Test B version of the PCB

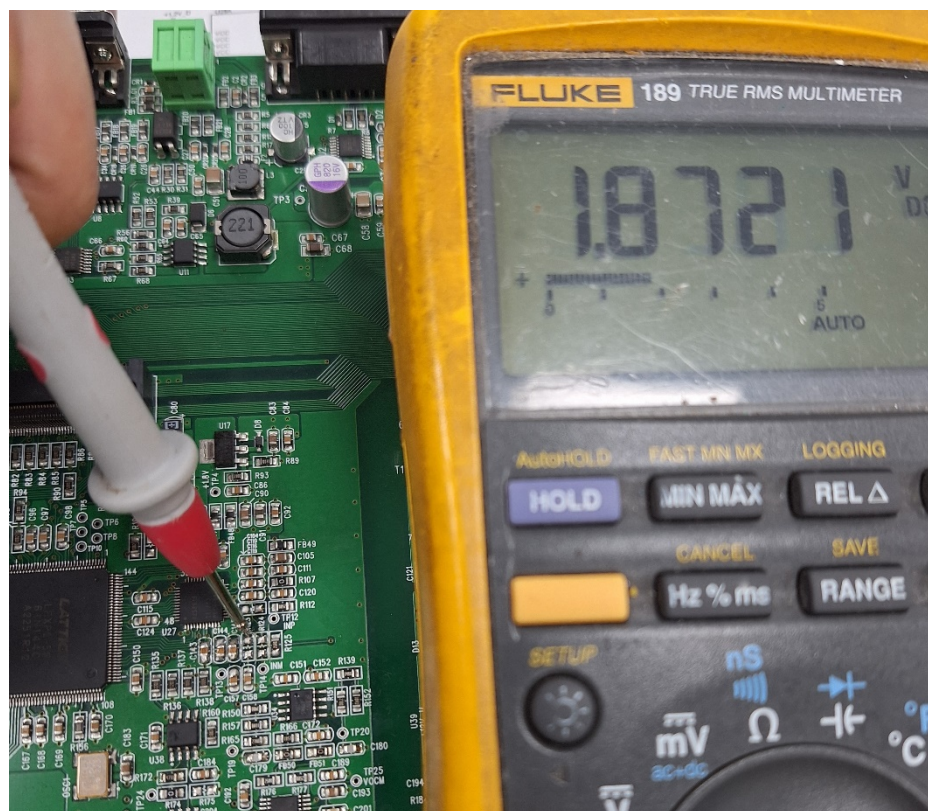
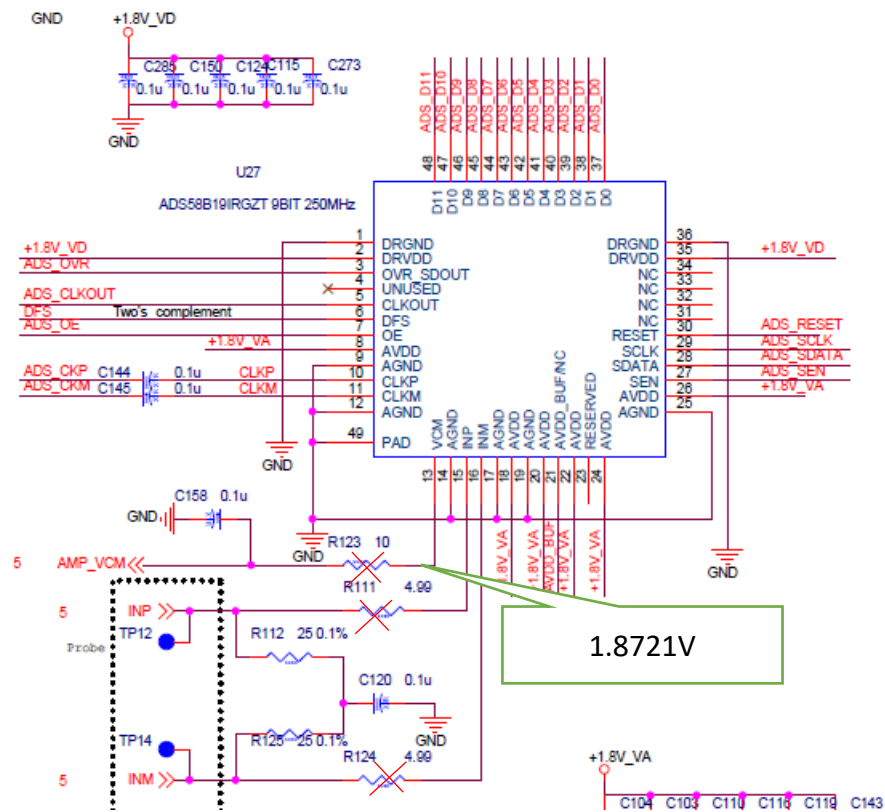
Delete R111, R124, R123

The measured VCM of the ADC is 1.8721V

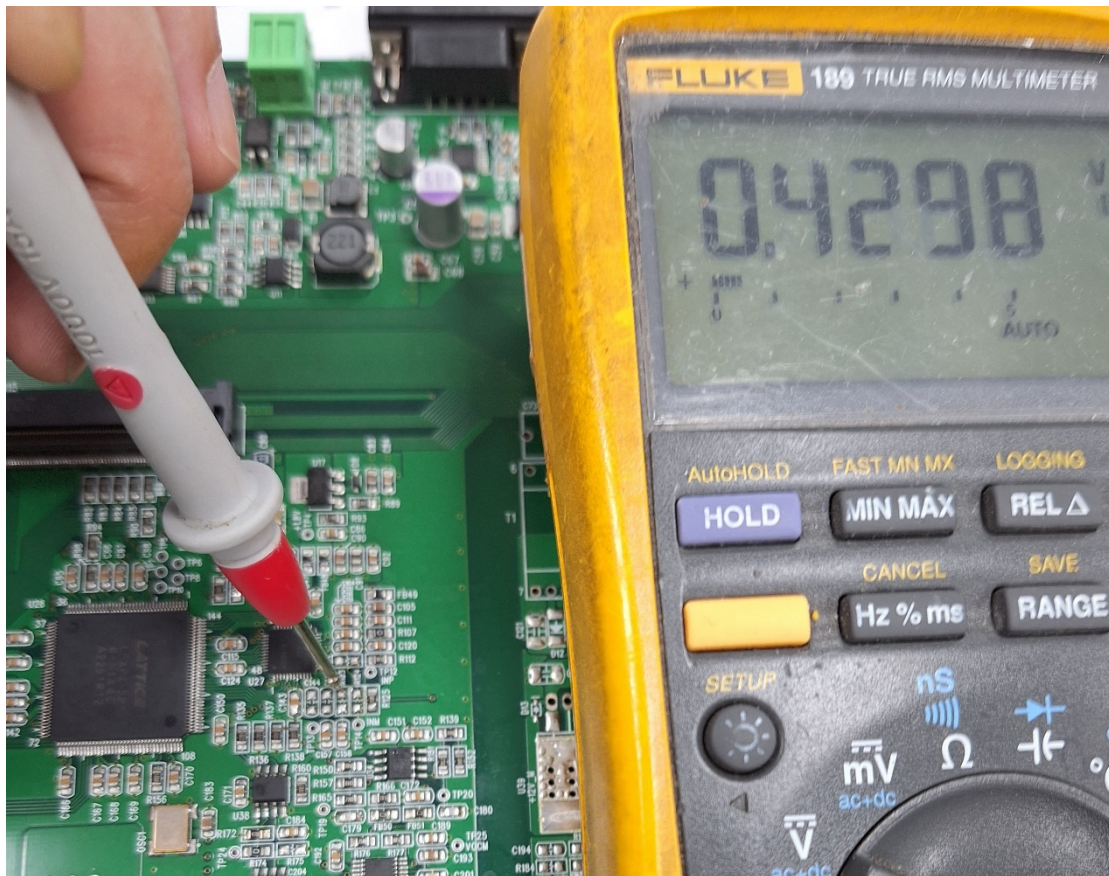
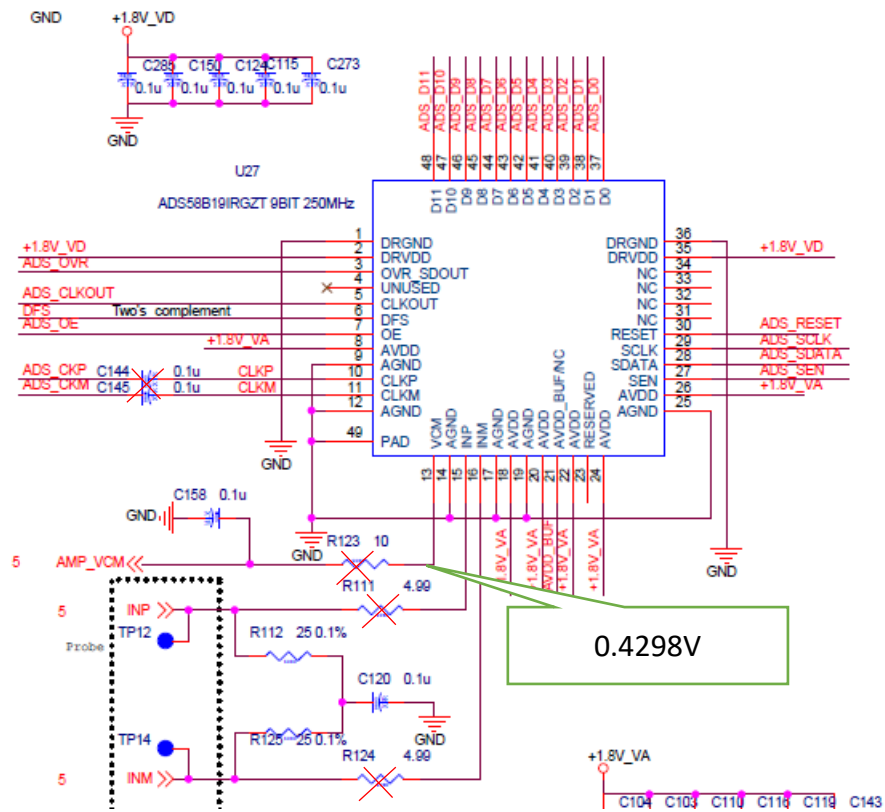
Delete R111, R124, R123,C144,C145

The measured VCM of the ADC is 0.4298V
